ACCESSION NBR: 8306270360 DOC. DATE: 83/06/20 NOTARIZED: NO DOCKET #  
 FACIL: 50-244 Robert Emmet Ginna Nuclear Plant, Unit 1, Rochester G 05000244  
 AUTH. NAME: MAIER, J. E. AUTHOR AFFILIATION: Rochester Gas & Electric Corp.  
 RECIP. NAME: CRUTCHFIELD, D. RECIPIENT AFFILIATION: Operating Reactors Branch 5

SUBJECT: Forwards addl info requested 830407 re containment pressure monitor, containment water level monitor & containment hydrogen monitors installed per requirements of TMI Items II.F.1.4, II.F.1.5 & II.F.1.6.

Subject: NUREG 0737, Items II.F.1.4, II.F.1.5, II.F.1.6  
R. E. Ginna Nuclear Power Plant  
Docket No. 50-244

REQUEST FOR ADDITIONAL INFORMATION ON NUREG-0737 ITEMS

FIGURE 1

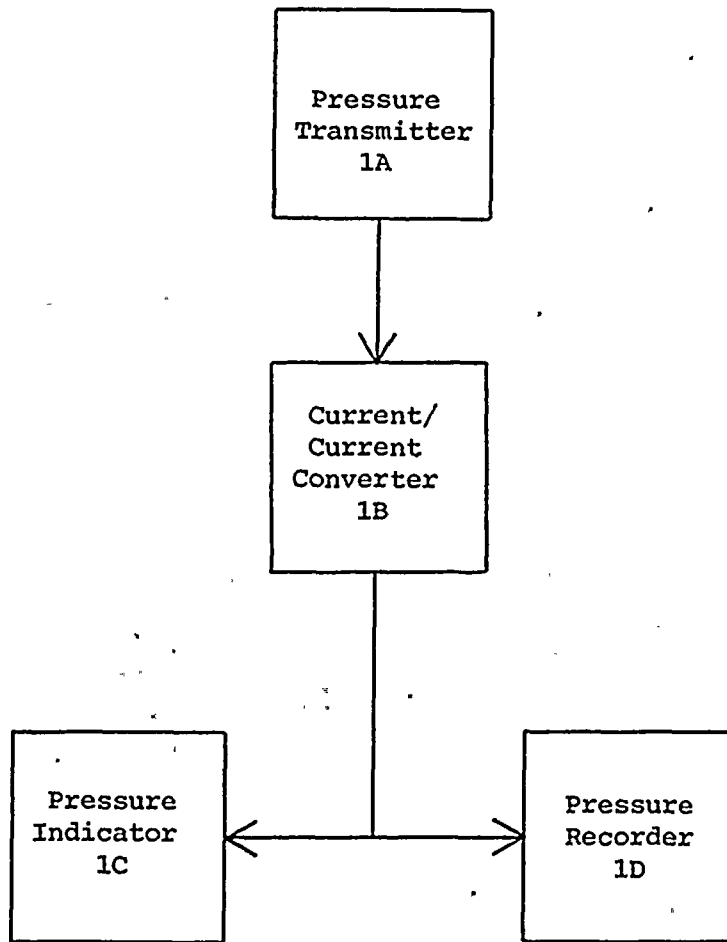
- (2a) Provide a block diagram of the configuration of modules that make up your PMS. Provide an explanation of any details in the block diagram that might be necessary for an understanding of your PMS accuracy and time response.

- (2c) Combine\*\* parameters in 2b to get an overall system uncertainty. If you have both strip chart recorder and indicator output, give the overall system uncertainty for both systems. If you have systems spanning different ranges, give the overall system uncertainty for each system.

(2d) For each module indicate the time response\*\*\*.

Rêspônse: See Figure 1 for block diagram.

Module Uncertainties (Ref. Fig. 1):

1A -  $\pm$  0.5% of span  
1B -  $\pm$  0.5% of span  
1C -  $\pm$  1.5% of span  
1D -  $\pm$  0.5% of span

Indicator Uncertainty =  $0.5 + 0.5 + 1.5 = 2.5\%$  of span

Recorder Uncertainty =  $0.5 + 0.5 + 0.5 = 1.5\%$  of span

1A - time constant = 0.478 seconds  
1B - negligible  
1C - 2.5 sec  
1D - 0.2 sec

FIGURE 2

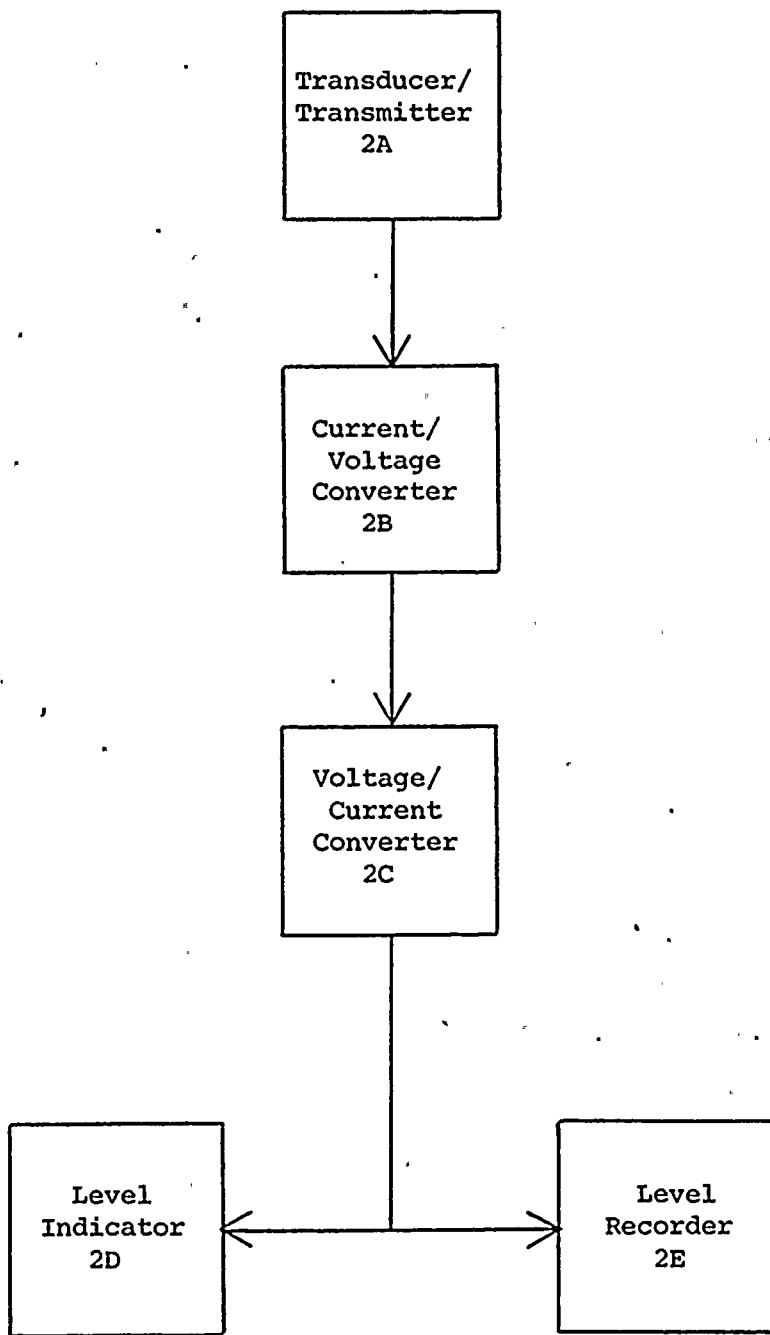
(3a) Provide a block diagram of the configuration of modules that make up your WLMS. Provide an explanation of any details in the block diagram that might be necessary for an understanding of your WLMS accuracy.

(3c) Combine\*\* parameters in 3b to get an overall system uncertainty. If you have both strip chart recorder and indicator output, give the overall system uncertainty for both systems. If you have systems spanning different ranges, give the overall system uncertainty for each system.

Response: See Figures 2 and 3 for block diagrams.

Narrow Range Containment Water Level (Ref. Fig. 2)

2A -  $\pm 0.24\%$  of span  
2B -  $\pm 0.25\%$  of span  
2C -  $\pm 0.5\%$  of span  
2D -  $\pm 1.5\%$  of span  
2E -  $\pm 0.5\%$  of span

Indicator Uncertainty =  $0.24 + 0.25 + 0.5 + 1.5 = 2.49\%$  of span

Recorder Uncertainty =  $0.24 + 0.25 + 0.5 = 1.49\%$  of span

FIGURE 4

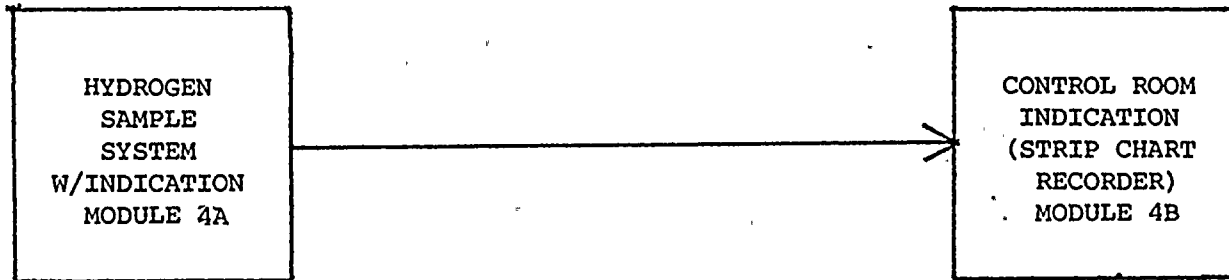
- (4a) Provide a block diagram of the configuration of modules that make up your HMS. Provide an explanation of any details in the block diagram that might be necessary for an understanding of your HMS accuracy. If you have different types of HMSs give this information for each type.

- (4c) Combine\*\* the parameters in 4b to get an overall system uncertainty. If you have both strip chart recorder and indicator output, give the overall system uncertainty for both systems.

Response: See Figure 4 for block diagram.

4A -  $\pm$  10% of span  
4B -  $\pm$  .25% of span

Algebraically Sum Uncertainties. Spans are the same.

$$\pm 10\% + \pm .25\% = \pm 10.25\%$$
